**Independent Scientific Review Panel**

**Review of the Monitoring and Evaluation Plan for the  
Walla Walla Spring Chinook Hatchery Master Plan (*public  
review draft*): Response Requested**

**Step Two of the Northwest Power and Conservation Council's  
Three-Step Review Process**

**ISRP 2015-7  
August 11, 2015**

Fig. A. Smolts per spawner in relation to the number of parent spawners in the Walla Walla subbasin. Values approximated by eye from Fig. 11 of the M&E report.

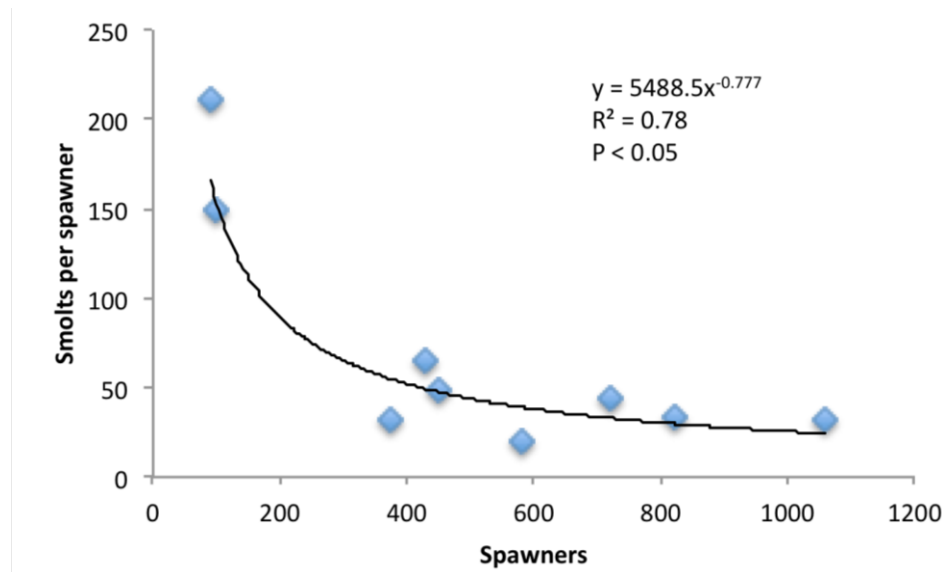
Chapter 2 provides evidence of density dependence during the spawner to smolt stage (e.g., Fig. 11). For example, the predicted number of smolts per spawner at high spawner abundances (1100 spawners, the Phase 2 target) is approximately 26 smolts per spawner. Predicted number of smolts per spawner, however, increases to approximately 77 smolts per spawner at 300 spawners and to 150 smolts per spawner at 100 spawners. In contrast, given an assumed Smolt-to-Adult Return (SAR) of 0.35% (Fig. 17), smolts per spawner must be approximately 285 or more to meet or exceed replacement ( $R/S = 1$ ). Please see ISAB ([2015-1](#); Figure VIII.1) for more discussion of this density dependence issue. Fig. A (below) provides an example of a plot of smolts per spawner in relation to the number of parent spawners in the Walla Walla subbasin.

The apparent density dependent relationship for naturally spawning spring Chinook in the Walla Walla subbasin suggests an opportunity for increasing harvests of surplus hatchery fish while also minimizing pHOS and therefore promoting the development of locally adaptive traits by the natural Chinook population. Consider the following scenario. For example, if 1,100 fish spawn naturally, approximately 100 natural-origin fish would return (assuming 26 smolts per spawner and  $SAR = 0.35\%$ ). In this example  $R/S$  is only approximately 0.091 and pHOS would likely be greater than 90% assuming 10% of NOR fish are taken for broodstock. However, if additional hatchery fish (HORs) were to be selectively harvested such that only approximately 300 Chinook spawn, then  $R/S$  would increase to approximately 0.27 or an approximate 3-fold increase. In this example, pHOS would decrease to approximately 76%, which is not

ideal but better than 90%, and additional Chinook could be harvested (assuming hatchery releases remain constant). Additionally, if fewer salmon spawn, juvenile Chinook may grow faster in the river (as a density dependent growth response which should be evaluated in the Plan) and this may increase the SAR of natural smolts so that pHOS might be further reduced. Note that when productivity and habitat capacity to produce salmon are evaluated, harvests are typically added to those fish returning to the river. Future M&E efforts should strive to incorporate harvests into the return estimates of natural adult Chinook so that life-cycle changes in capacity and productivity can be accurately evaluated.
